AMD-K6[®]

Processor Revision Guide

Model 7

Publication # 21846 Rev: G Amendment/0 Issue Date: August 1998
--

Figure 1. AMD-K6[®] Processor Assertion of HLDA Due to Simultaneous BOFF/HOLD Assertion

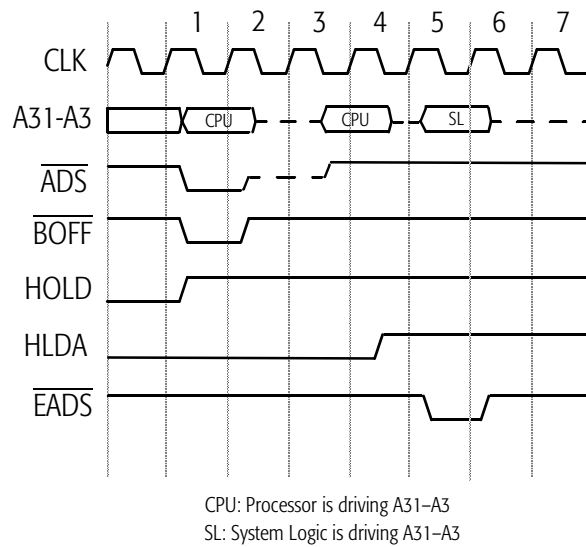
Normal Specified Operation. If $\overline{\text{BOFF}}$ and HOLD are sampled asserted on the same clock edge that negates $\overline{\text{ADS}}$, the processor asserts HLDA one clock edge after HOLD is sampled asserted.

Non-conformance. If $\overline{\text{BOFF}}$ and HOLD are sampled asserted on the same clock edge that negates $\overline{\text{ADS}}$, the processor asserts HLDA two clock edges after HOLD is sampled asserted.

Potential Effect on System. There are three potential effects of this erratum to consider:

- If the system logic asserts $\overline{\text{BOFF}}$ for a duration of one clock, anticipates the assertion of HLDA in clock 3 (see Figure 1)—which is the normal specified operation—and drives the address bus and $\overline{\text{EADS}}$ for an inquire cycle in clock 3, then the processor will not sample $\overline{\text{EADS}}$ asserted. In addition, address bus contention will occur in clock 3.

- If the system logic asserts $\overline{\text{BOFF}}$ for a duration of two clocks, anticipates the assertion of HLDA in clock 3, and drives the address bus and $\overline{\text{EADS}}$ for an inquire cycle in clock 3, then the processor will not sample $\overline{\text{EADS}}$ asserted. (No address bus contention occurs in this case.)

- If the system logic asserts $\overline{\text{BOFF}}$ for a duration of one clock, anticipates the assertion of HLDA in clock 3, and drives the address bus and $\overline{\text{EADS}}$ for an inquire cycle in clock 4, then address bus contention may occur in clock 4. (The processor will sample $\overline{\text{EADS}}$ asserted in this case.)

If the processor does not sample $\overline{\text{EADS}}$ asserted during an inquire cycle, cache/memory incoherency will occur. Address bus contention can affect the reliability of the processor and the system logic.

Suggested Workaround. The system logic must sample the assertion of HLDA before asserting $\overline{\text{EADS}}$ and driving the address bus for an inquire cycle—as shown in clock 5 of Figure 1.

Resolution Status. AMD has determined that all Socket7 and Super7[™] chipsets operate as described in the aforementioned suggested workaround. Therefore, AMD has decided to defer the resolution of this erratum until deemed necessary.
